Job No. 185466

Re: Response to:  
Colorado Geological Survey Review Comments, dated June 6, 2022 and  
El Paso County Planning and Community Development Comments, dated June 1, 2017.

## **SOILS AND GEOLOGY STUDY**

**Lots 1 and 2  
Owl Ridge Subdivision  
El Paso County, Colorado**

FIG No. 4

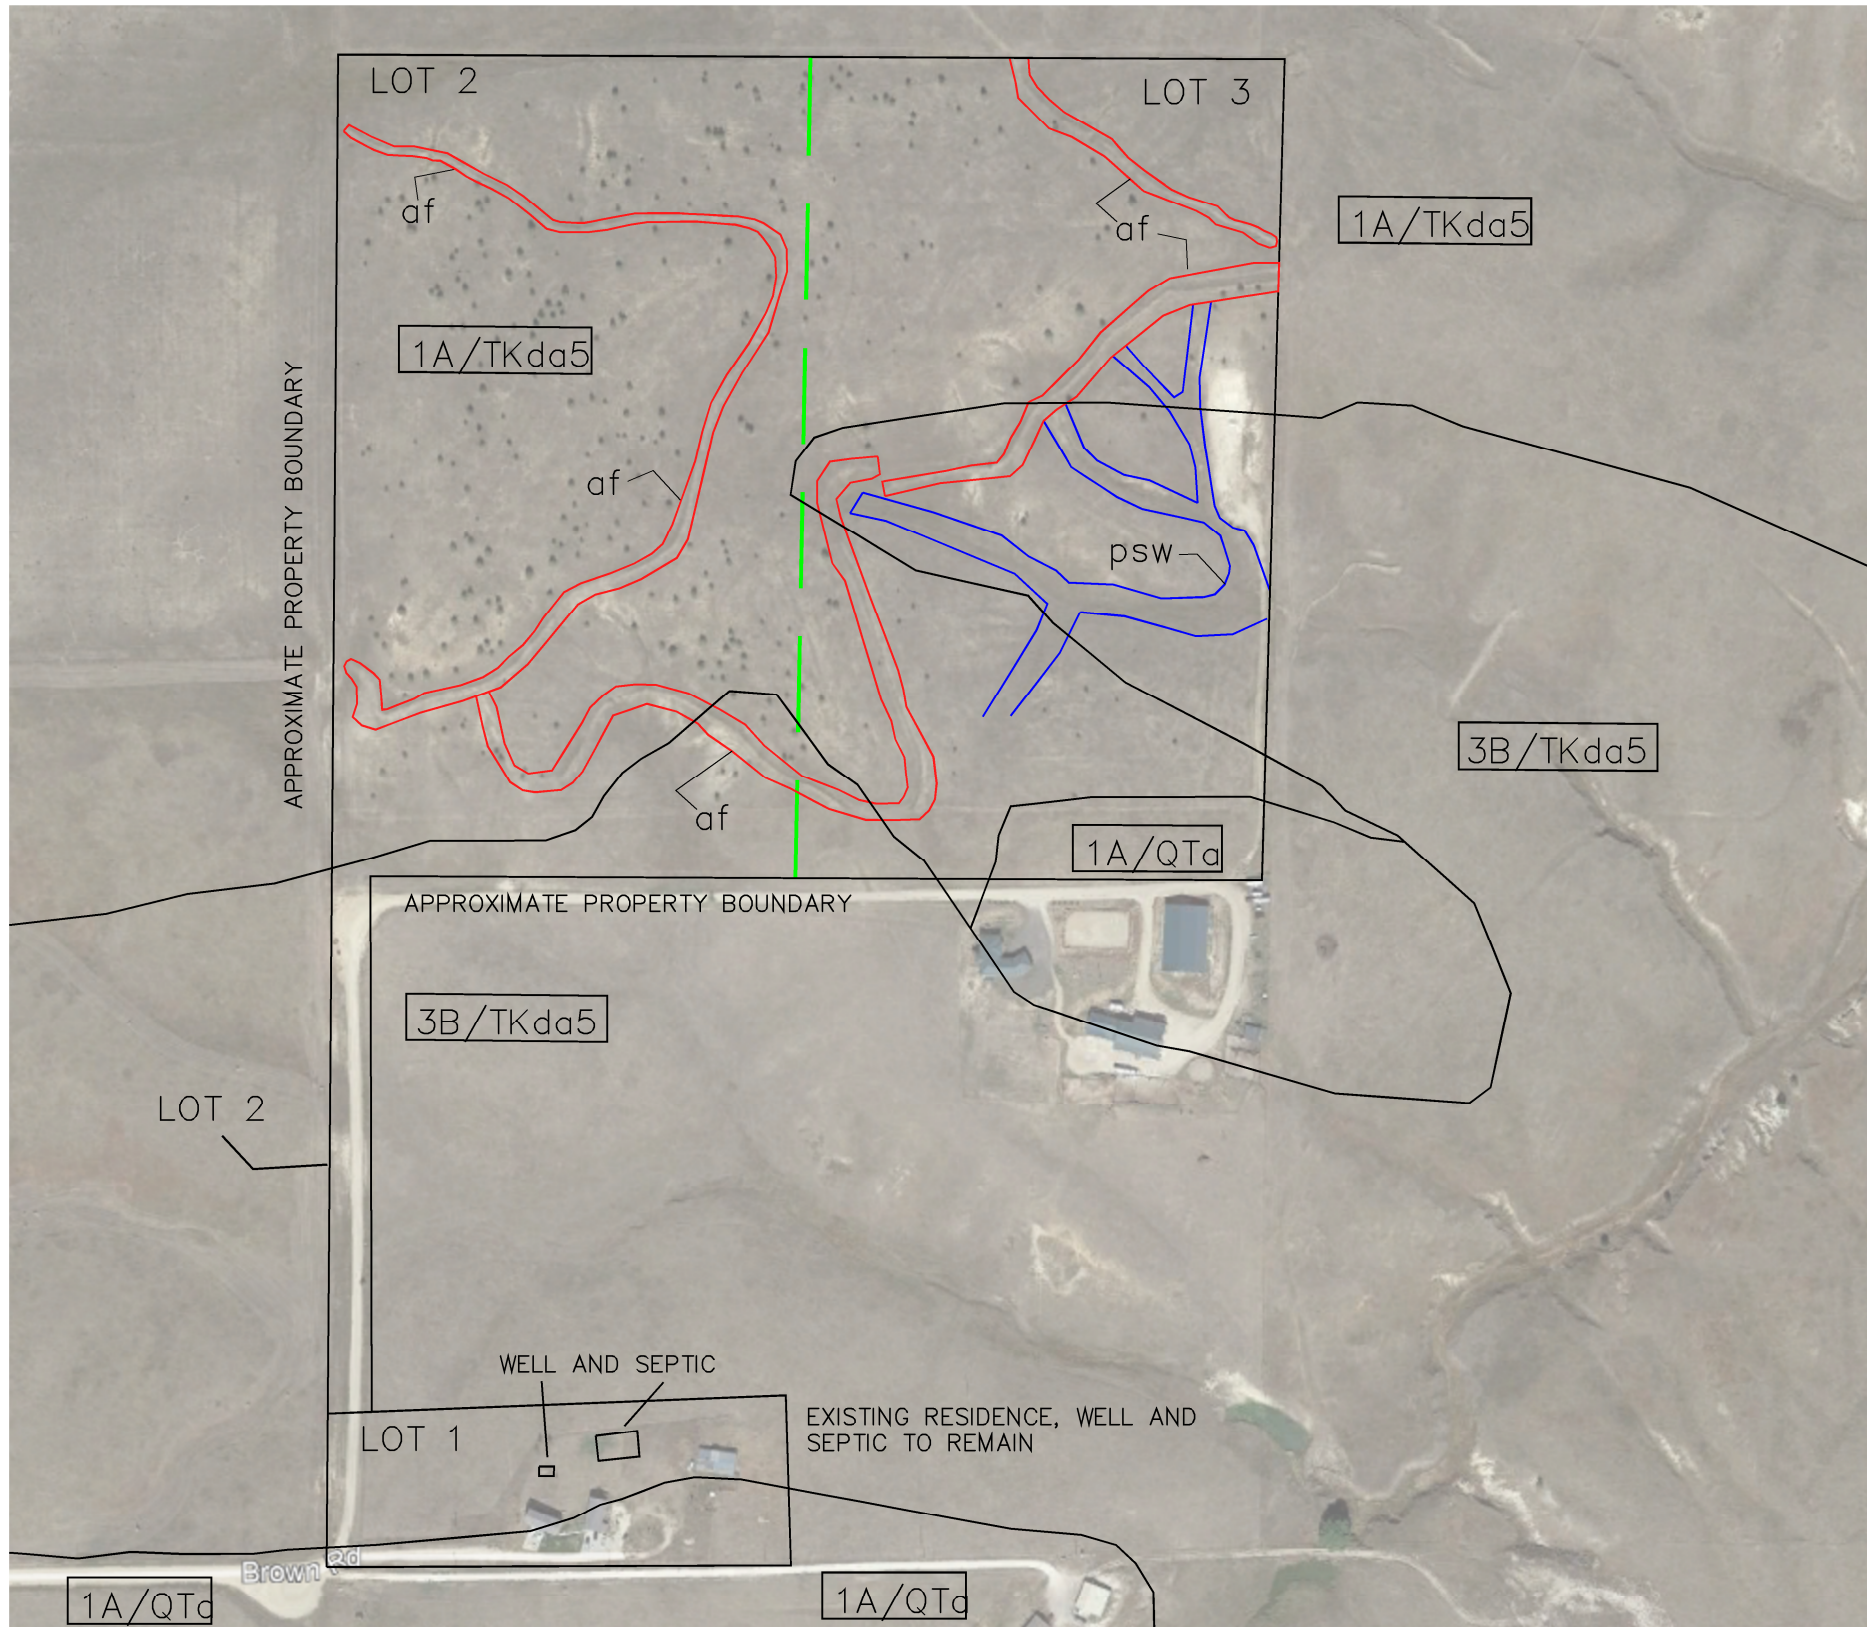
Test pits described on Pg 6 need additional information per Engineering Criteria Manual Appendix C for Geologic Report guidelines Section C.2.2.6

Test Pits and Trenches. The test pit and trench information shall: • Describe the location and dimensions of all pits and trenches and date of investigation; • Indicate the location of all excavations on the topographic/geologic map and profiles; • Provide a large scale descriptive log with sufficient detail; and, • Show sample location if supplemental laboratory tests were conducted.

- The Test Pits locations are included on Figure 5 of the amended report. The Test Pit Logs, Figure 4 have also been included.

- The Test Pits Logs are included on Figure 5 of the amended report.
- The test pit locations are indicated on the Engineering and Geology Map, Figure 5.

FIG-5

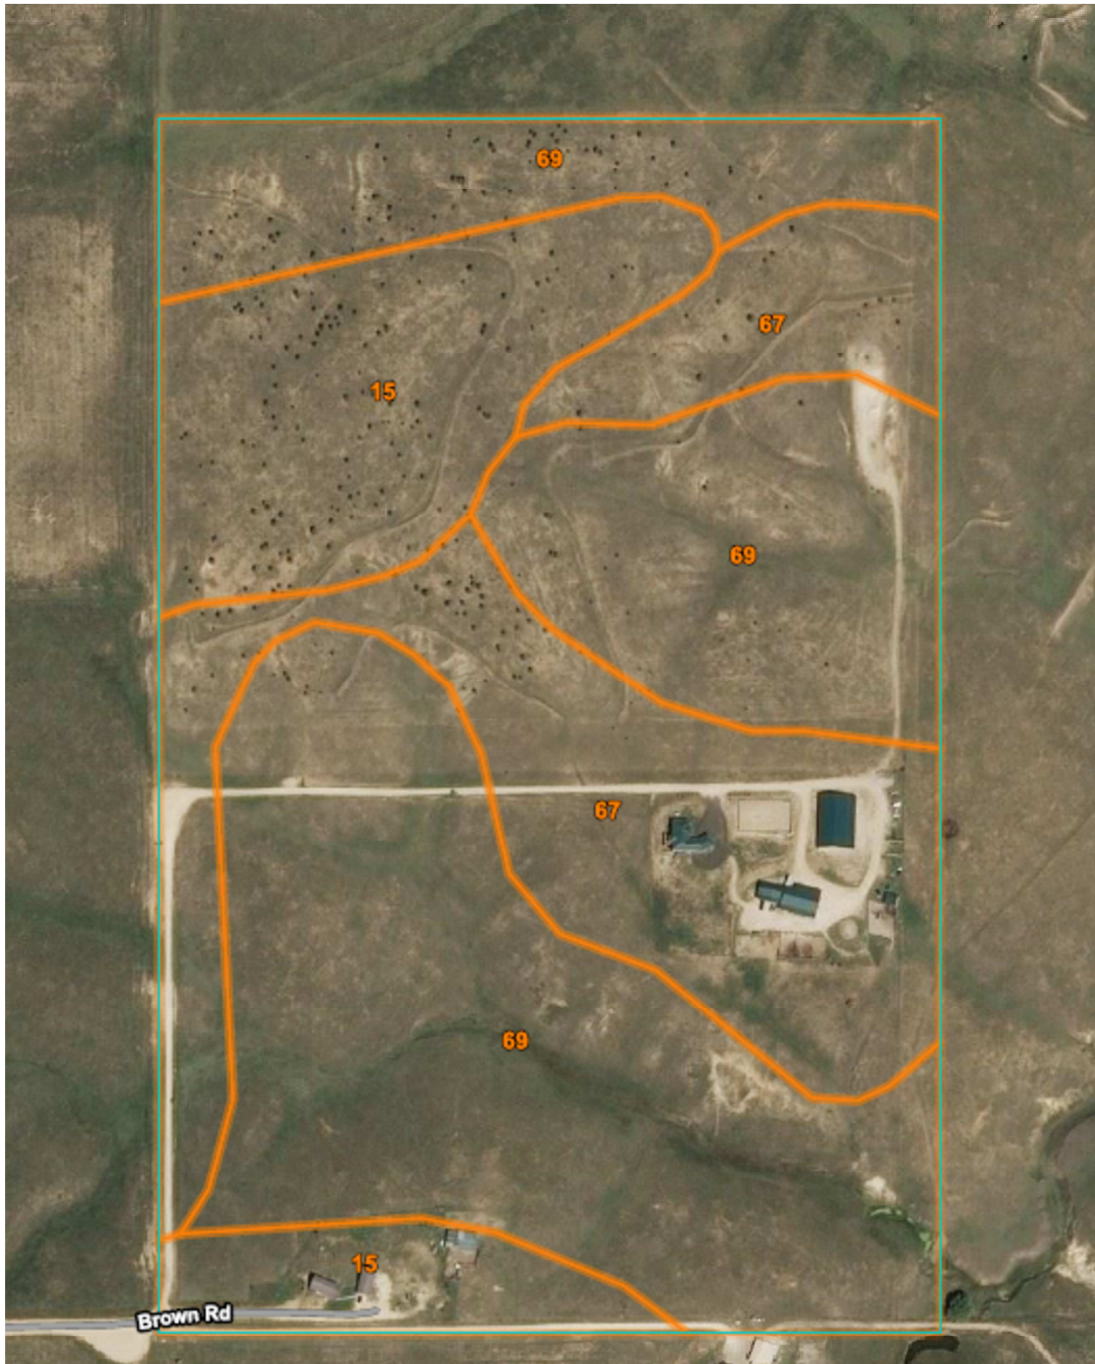
depths where both are likely to be shallow. The Engineering and Geology Map (figure 4) also designates areas within lot 3 as "potentially seasonally wet area." Mitigation measures for this hazard/constraint are not included in RMG's report. The expanded report should also include a discussion on groundwater conditions. If shallow groundwater is encountered or expected based on the subsurface conditions, the report should discuss the expected seasonal groundwater fluctuation expected at the site based on site-specific data and the feasibility of basements or other anticipated habitable below-grade space.

See CGS review comments to be addressed on seasonal wet areas on Fig 4 and expected seasonal groundwater fluctuations etc. The drainage report depicts a proposed building site potentially directly in the area shown as season wet area.

- The CGS comments have been addressed in our responses above and in the amended report.
- The Drainage Report is outside the scope of the Soils and Geology Study. The Owl Ridge Subdivision, Final Drainage Report, last dated March, 2022 prepared by SMH Consultants, Figure 4, shows the proposed building location for Lot 3, approximately 7,000 SF between the seasonally wet areas, as mapped by RMG. At this time, construction is not proposed on Lot 3. However, if construction is proposed in the future, a site specific subsurface soil investigation is recommended to verify the depth of groundwater. It is recommended that future structures be located outside any potentially seasonally wet areas.
